Proposed AD Plant, Bressingham

Stage 1 Road Safety Audit

Reference: PC4115-RHD-ZZ-XX-RP-SA-0002

Document title: Deal Farm, Bressingham

Figure 3 – Problem Location Plan

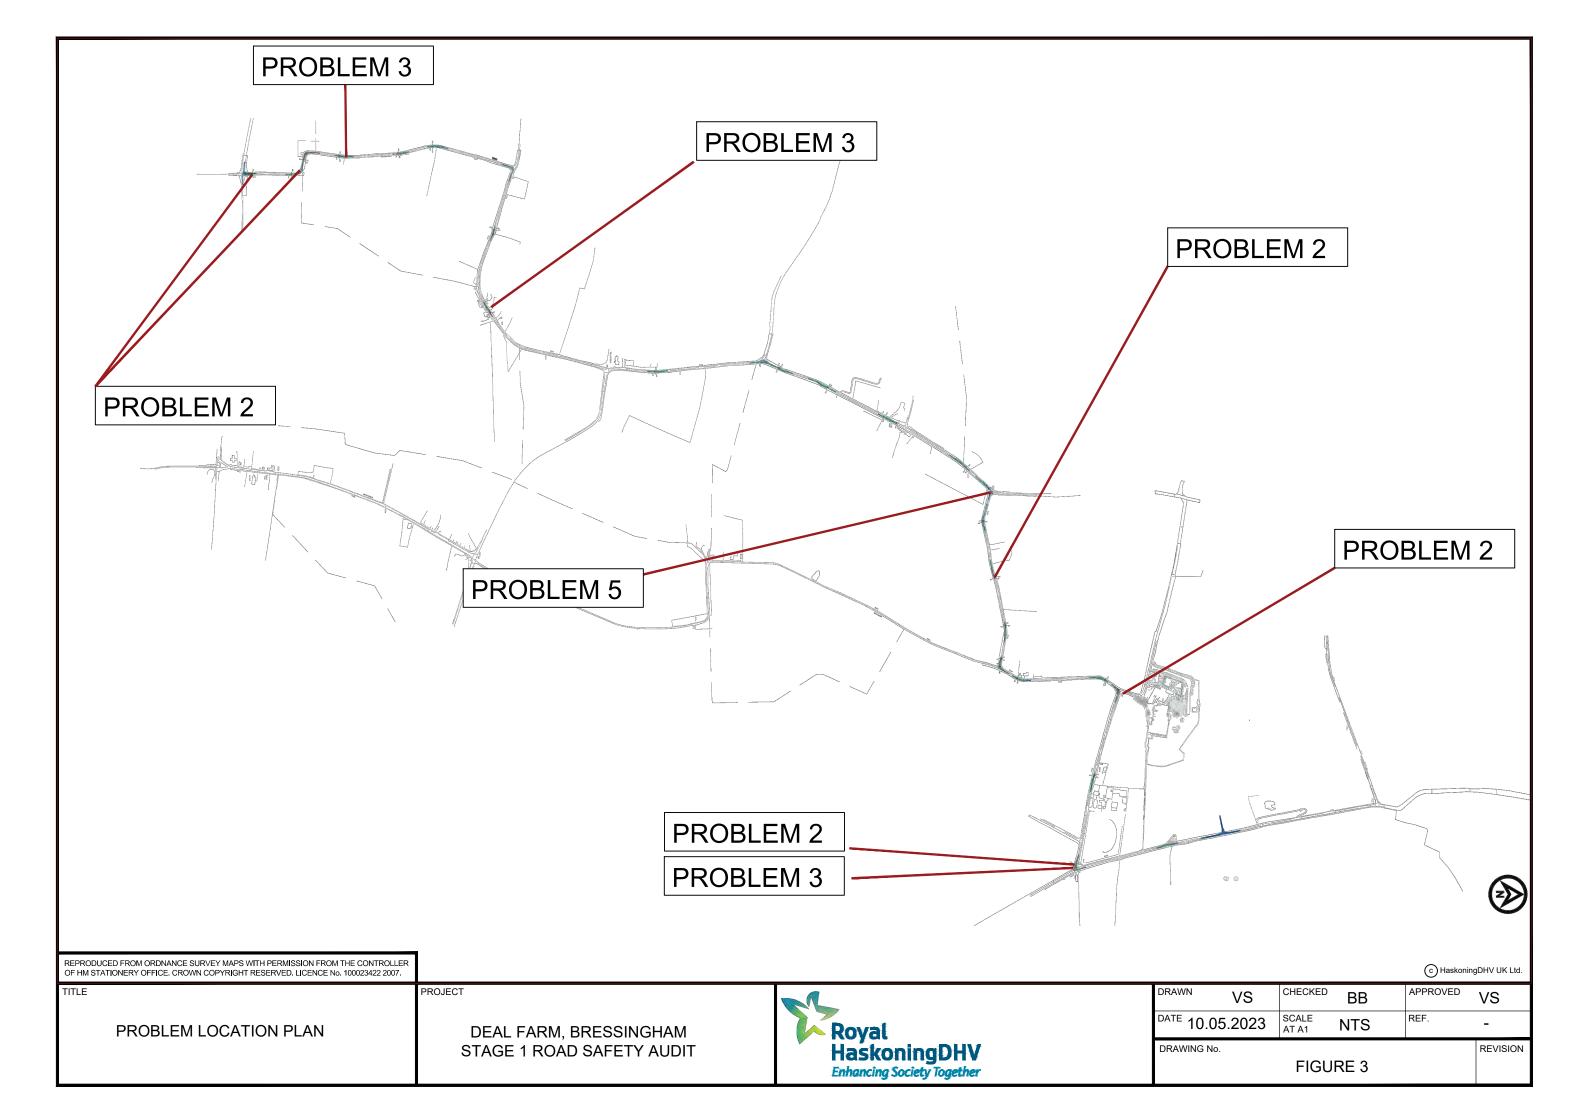
A similar scheme was subject to a Stage 1 Road Safety Audit in October 2022. The revised scheme would provide 25 no. passing places/ junction modifications on approximately 4.5 kilometres (km) of existing rural roads. The locations of the passing places have been numbered for ease of identification within this Stage 1 Road Safety Audit. The passing places and identification numbers are shown on **Figure 2** of this report. The locations of any problems identified by the Audit Team are shown on **Figure 3** of this report.

Summary: Insufficient forward visibility in advance of, and/ or within the vicinity of the proposed passing places could result in sudden braking leading to the potential for rear end shunts or loss of control collisions.

Description: Landscaping earth banks and the alignment of the existing carriageway currently restrict forward visibility between road users in the vicinity of 10 no. of the proposed passing places. Failure to provide and maintain adequate forward visibility could result in conflicts between oncoming vehicles or sudden braking leading to rear end shunts or loss of control collisions.

Summary: Collisions with street furniture/ trees could lead to the potential for collapse of the infrastructure, leading to injuries or to subsequent collisions.

Description: The proximity of the passing places (and the reconfiguration of existing junctions) to signs, telegraph poles and trees could lead to collisions with these items as vehicles are manoeuvring into the passing facilities. Collisions with street furniture and trees could result in injuries or to damage to the infrastructure leading to collapse and subsequent collisions.

Summary: Proximity of proposed passing places to drainage ditches could result in vehicles inadvertently leaving the carriageway with the potential for injury.

Description: Some of the passing places appear to be located immediately adjacent to deep drainage ditches. Vehicles manoeuvring into/ out of the passing places could inadvertently leave the carriageway to the nearside, sliding into the ditches or entering the adjacent fields, resulting in the potential for injuries to vehicle occupants.

Summary: Vehicles overhanging the main carriageway could lead to side swipe collisions with passing traffic leading to the potential for damage and secondary collisions elsewhere on the highway.

Description: Earth banks are present adjacent to two of the proposed passing places. The presence of these boundary features could restrict the available space to provide a passing place of sufficient width to accommodate a vehicle without overhanging the main carriageway. Vehicles overhanging the main carriageway could lead to swipe collisions with passing traffic resulting in the potential for damage and secondary collisions elsewhere on the highway.

Summary: Reduced conspicuity of the location of a fire hydrant could lead to high severity injuries or significant damage to property in an emergency situation.

Description: A fire hydrant marker is present on the grassed island at the junction of Lady's Lane and Kenninghall Road. Drawing PC4115-RHD-ZZ-ZZ-DR-D-0005 P06 indicates that the island would be removed in order to accommodate HGV movements. Information provided to the Audit Team does not provide details in relation to the relocation of the hydrant marker or whether it may be necessary to relocate access to the hydrant itself. Failure to relocate the sign to a suitable location could result in delays in obtaining access to the hydrant during an emergency situation, leading to the potential for high severity injuries or significant damage to property.

Paragraph No. in Safety Audit Report	Problem Accepted (yes/no)	Recommended Measure accepted (yes/no)	Description / alternative measure
A1.1.1	Yes	Yes	Visibility checks have been done and shown on the drawings. Notes added for any vegetation/ obstruction to the visibility to be cleared. At detailed design stage, visibility to be reviewed with the topographical survey.
A1.2.1	Yes	Yes	The designer tried to avoid the existing furniture in the design as much as possible, however, affected trees/utilities are highlighted on the drawings. The exact location of affected street furniture to be reviewed/refined at detailed design stage based on a topographical survey.
A1.2.2	Yes	Yes	A kerb is proposed at the edge of the passing bay to keep vehicles safe and away from the ditch. A short pipe culvert is proposed for passing places 20,21,23 where the passing place is on top of existing ditch. The affected ditch areas are located in developers' land. Culverted ditch locations to be reviewed at detailed design stage with the topographical survey.

A1.2.3	Yes	Yes	As shown on the swept path analysis drawings, an oil tanker and a large car can pass side by side. The overhang to be checked with topographical survey at detailed design stage.
A2.1.1	Yes	Yes	A note is added to the drawing, highlighting the location of the fire hydrant. At detailed design stage, designer to liaise with the relevant authority for fire hydrant exact relocation.
